NEW HORIZON ACADEMY - DOUGLAS 234 FILING, NO. 6 PARKER, CO

Project Status: TOWN REVIEW 8/26/2020, TOWN REVIEW 1/22/2021, TOWN REVIEW 3/22/2021, TOWN REVIEW 6/4/2021

COVER SHEET

WATER & SEWER CONSTRUCTION PLANS FOR NEW HORIZON ACADEMY

U0.0

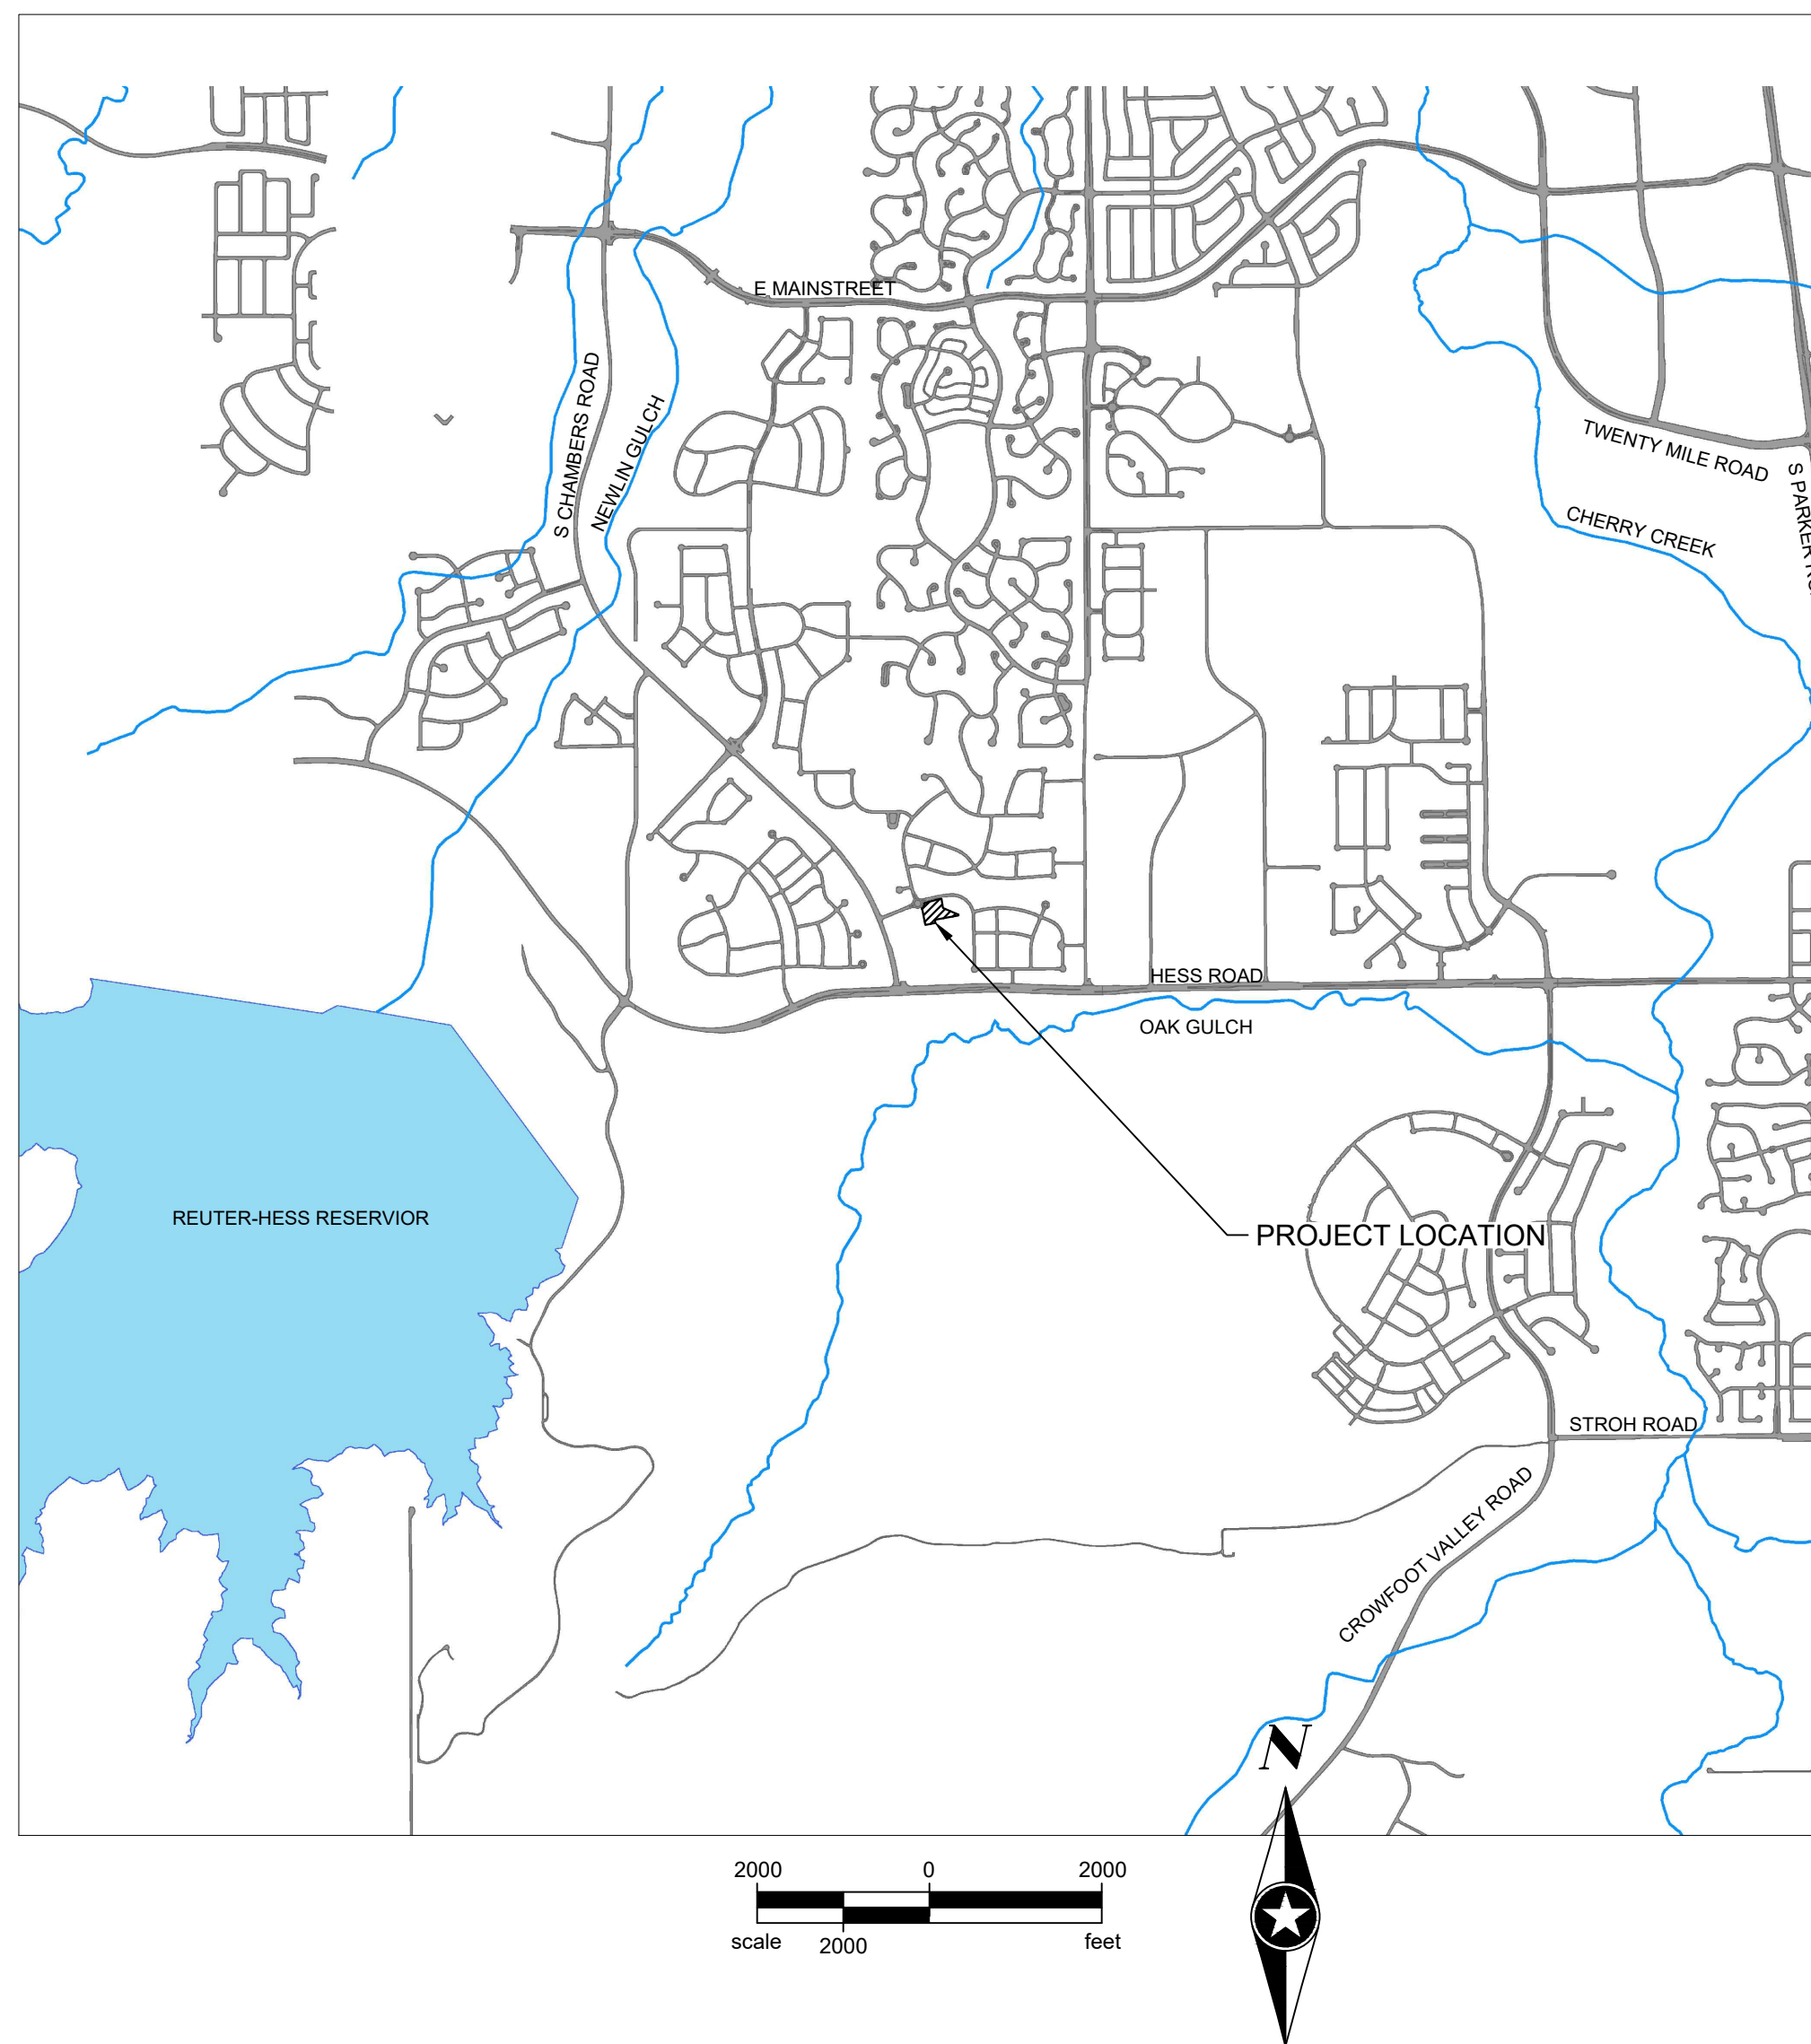
Add Engineering firm contact information

Materials list is incorrect.
